# CITY OF ALBUQUERQUE

May 16, 2025

**RE: 705 14<sup>th</sup> Street NW**  
**Grading and Drainage Plan**  
**Engineer's Stamp Date: 5/11/25**  
**Hydrology File: J13D225**  
**Case # HYDR-2025-00166**

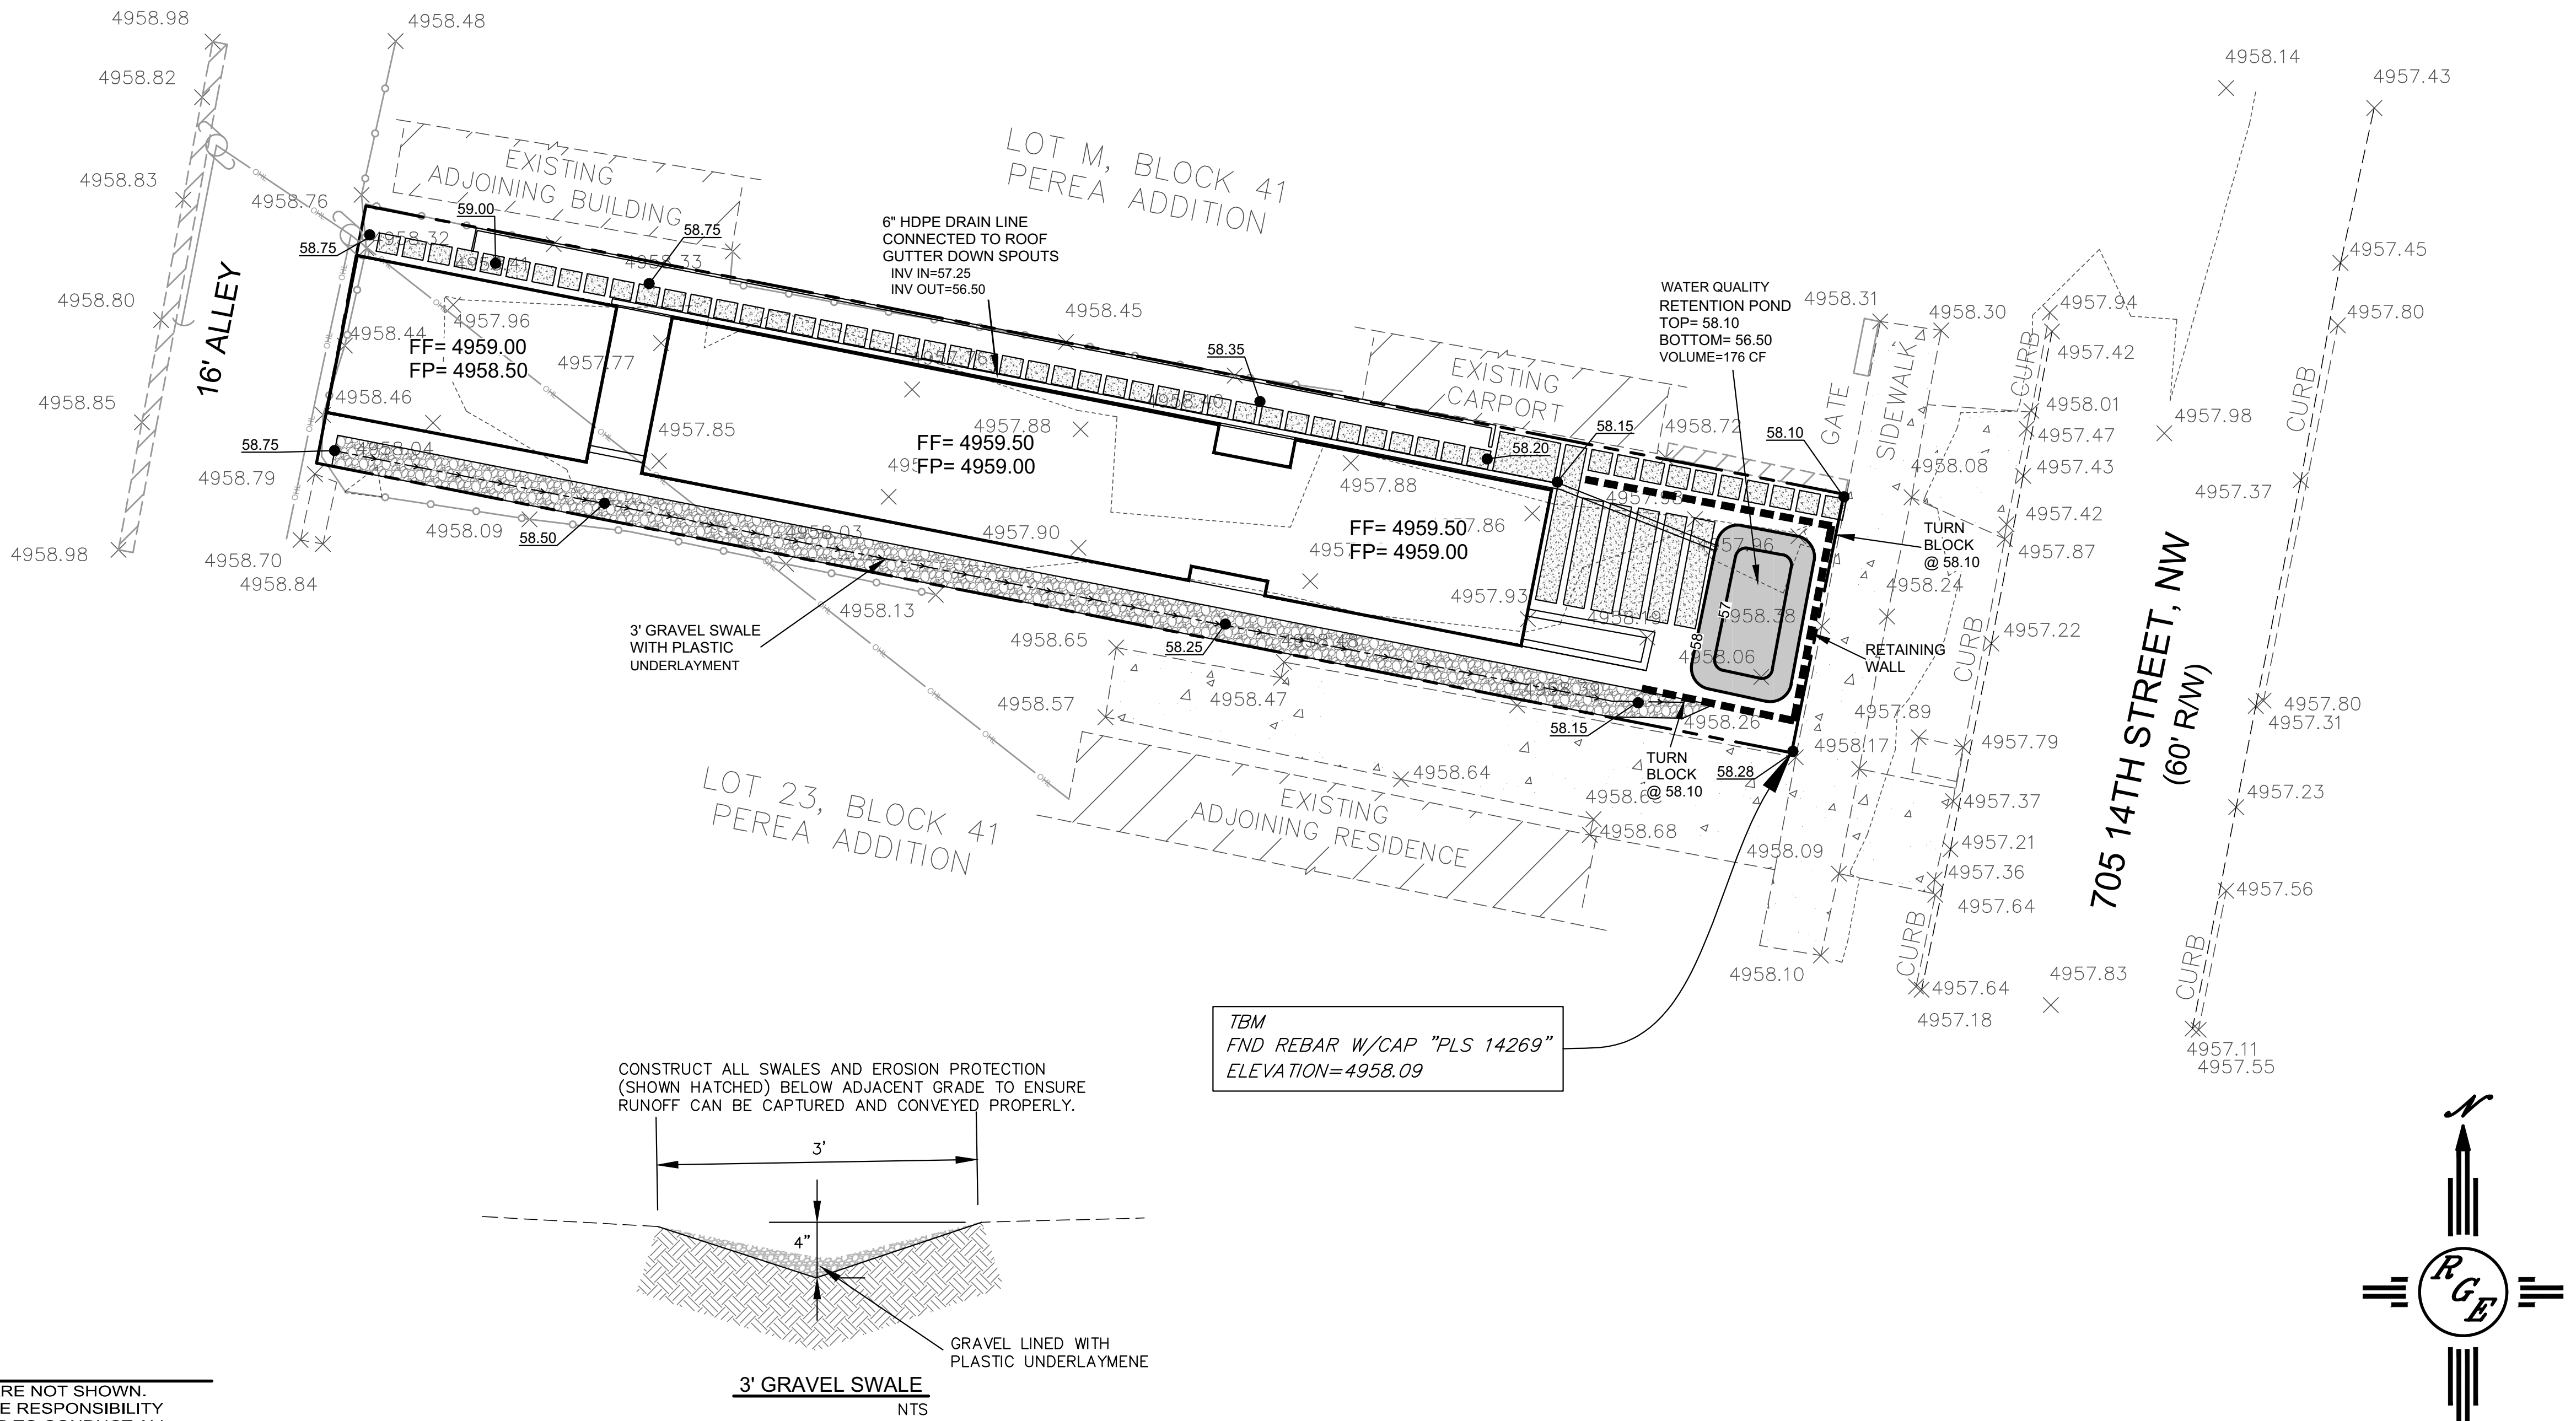
Based upon the information provided in your submittal received 5/12/2025, the Grading plan is **approved** for Building Permit and Grading Permit. Please attach a copy of this approved plan in the construction sets for Building Permit processing along with a copy of this letter.

1. Engineer's Certification, per the DPM Part 6-14 (F): *Engineer's Certification Checklist For Non-Subdivision* is required.
